SECTION 645 - TRAFFIC CONTROL DEVICES

Make the following amendments to said Section:

- (I) Amend the title to read as "SECTION 645 WORK ZONE TRAFFIC CONTROL"
- (II) Amend Table 645-I For Traffic Control Plan to read as follows:

TWO-LANE HIGHWAY - ONE LANE CLOSED FIGURE 1 - TRAFFIC CONTROL PLAN

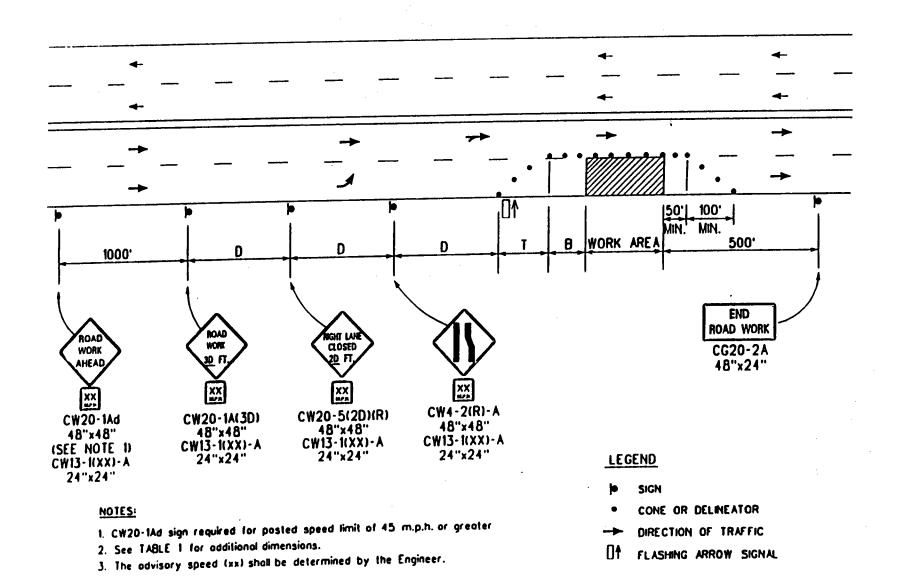
(VI) Replace Figures 1 through 6 dated 5/01/93 with the attached Figure 1 dated r11/97, Figure 2 dated r2/97 and Figures 3 through 7 dated r10/96.
